Calvert Cliffs Nuclear Power Plant, Units Nos. 1 and 2
Renewed Facility Operating License Nos. DPR-53 and DPR-69
NRC Docket Nos. 50-317 and 50-318

Calvert Cliffs Nuclear Power Plant
Independent Spent Fuel Storage Installation, License No. SNM-2505
NRC Docket No. 72-8

Subject: Response to Amendment Request No. 1 to Renewed Materials License No. SNM-2505 for the Calvert Cliffs Specific ISFSI – First Request for Additional Information

RESPONSE TO REQUEST FOR ADDITIONAL INFORMATION

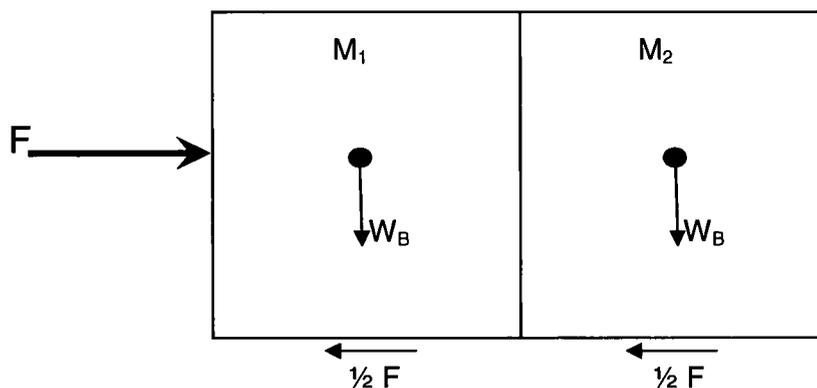
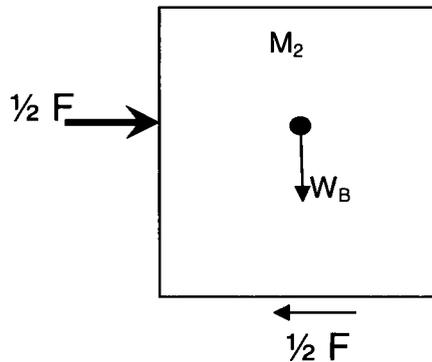
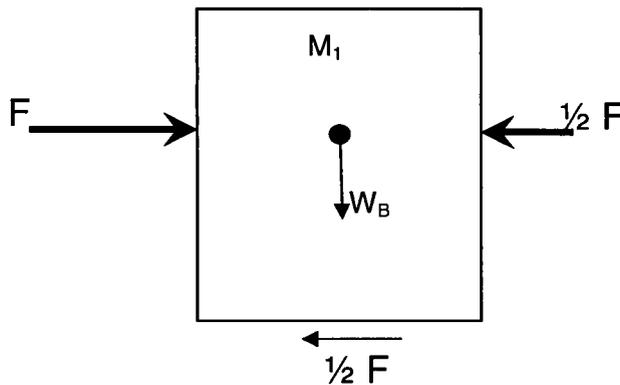
Explain rationale behind the 0.5 multiplication factor for the calculations involving the HSM-HB overturning due to flood load and the Horizontal Storage Module (HSM) HB sliding due to flood load in reference 13.10 of the Updated Safety Analysis Report (USAR).

Reference 13.10 is Transnuclear Calculation No. NUH32PHB-0208, HSM-HB Structural Analysis for NUHOMS®-32PHB System Design Calculation. The staff notes that in these calculations, the drag force used for the overturning moment and the sliding force is multiplied by a factor of 0.5. The explanation for this factor is, "50% of the drag force is assumed to act on one face of one module and 50% on opposite face of the adjacent module." Assumption number 6 states, "For stability analysis of the HSM-HB subjected to flood load a minimum of two modules adjacent to each other are required to prevent overturning and sliding." It is not clear how the interaction of the two modules reduces the drag force by 50%.

The calculation NUH32PHB-208 considered two modules to be exposed to the total flood load. Since the modules in the pair are in contact, the total flood load is anticipated to be distributed equally to both modules. As discussed in Section 1.3.1.2 of the Calvert Cliffs ISFSI USAR, the ISFSI employs HSMs constructed in units of 12 configured in a 2x6 array. In an array of 6 HSMs with all the modules in contact, the total flood load is distributed among all the modules in the array. Therefore, the net force acting on a single module in the array direction, in reality, will be even lower than one half of total flood load.

The rationale behind the use of 0.5 multiplication factor in NUH32PHB-208 for the calculations involving the HSM-HB overturning and sliding due to flood load is explained below.

Consider the following free-body diagram with the total flood force, F , acting on a pair of HSM modules, M_1 and M_2 . The vertical reactions due to the buoyant weight are not shown in the free-body diagram.

Let W_B be the buoyant weight of each module. The non-sliding friction forces due to the buoyant weight have not reached their sliding limit. Therefore, the sum of reactions at the base of each module equals the applied force (F). These reaction forces are developed due to the static friction at the base of each module. Due to similar weight, configuration and design, each module will have equal reaction force i.e., one half of the applied force.

The free body diagram of the module M_2 is:

The free body diagram of the module M_1 is:

Based on the above free body diagram of individual HSM module, the net force acting on each HSM module is $\frac{1}{2}F$.

Therefore, it is conservative and justified to use the multiplication factor of 0.5 in the calculations involving overturning and sliding of HSM-HB due to flood load.
